June 19, 2009

Subject: SLIC Case No. RO0002466 and Geotracker Global ID T06019744728, Park Street Landing
2301-2337 Blanding Avenue, Alameda, CA 94501

Alameda County Environmental Health (ACEH) staff has reviewed the Spills, Leaks, Investigations, and Cleanups (SLIC) case file for the above referenced site including the recently submitted document entitled, "*Addendum to Work Plan for Additional Site Assessment*," dated May 28, 2009 and prepared on Chevron's behalf by Conestoga-Rovers & Associates. The Work Plan Addendum presents subslab sampling locations as requested in our previous correspondence dated April 2, 2009.

Attachment 1: Alternate Sub-Slab Sampling Locations

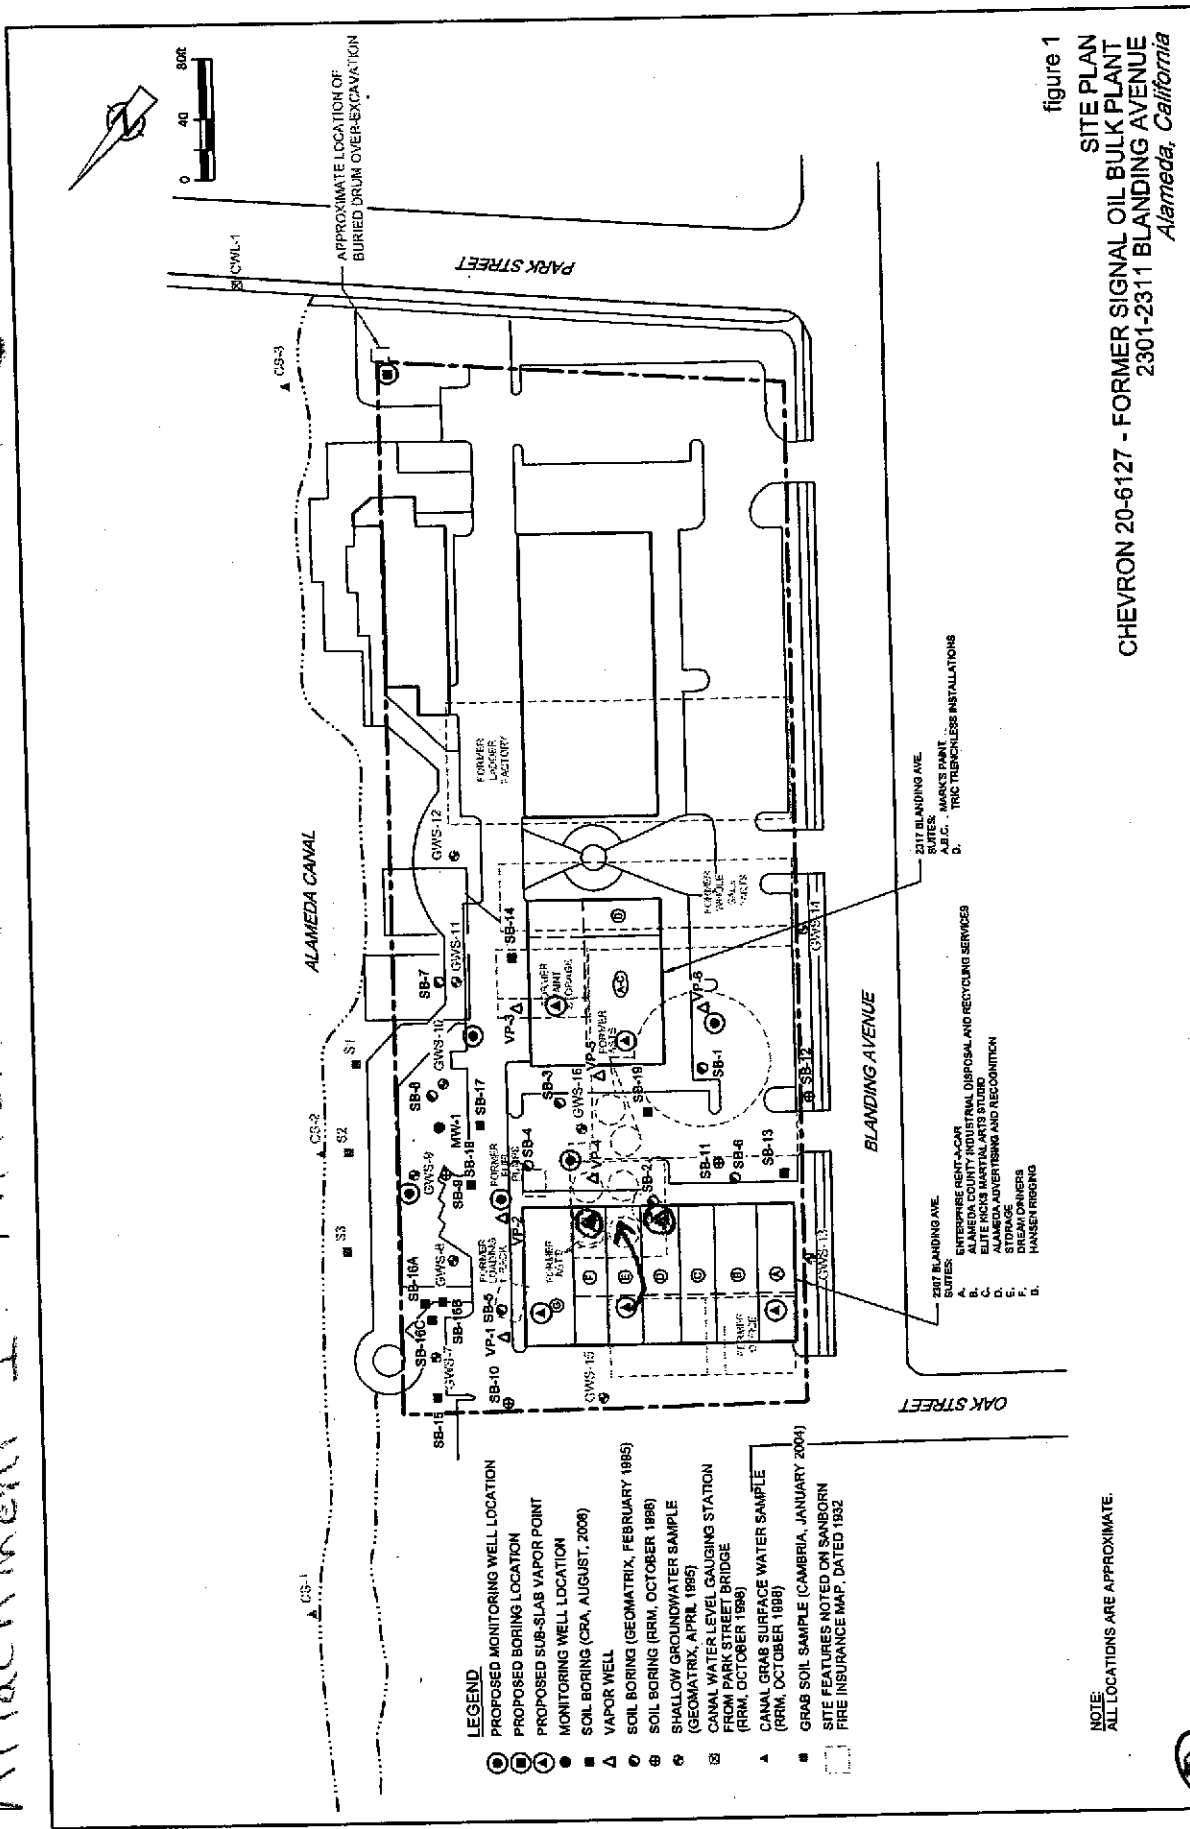
As discussed in the technical comments below, the proposed sampling locations are not adequate to assess potential vapor intrusion for the on-site building at 2307 Blanding Avenue. Attachment 1 to this correspondence suggests alternate sub-slab locations that would be acceptable. Therefore, you may implement the proposed sub-slab sampling using the alternate locations shown on Attachment 1 or you may submit a Revised Work Plan Addendum that proposes alternate locations that address technical comment 2.

are outside the areas of concern. The nearest proposed sub-slab sampling location is approximately 80 feet from VP-4. Given that the contamination may be within the vadose zone, the proposed locations are too far from the suspected sources and occupied spaces to evaluate potential vapor intrusion for 2307 Blanding Avenue. Attachment 1 to this correspondence suggests alternate sub-slab locations that would be acceptable. Therefore, you may implement the proposed sub-slab sampling using the alternate locations shown on Attachment 1 or you may submit a Revised Work Plan Addendum by July 2, 2009 that proposes alternate locations that address the issues discussed in this technical comment.
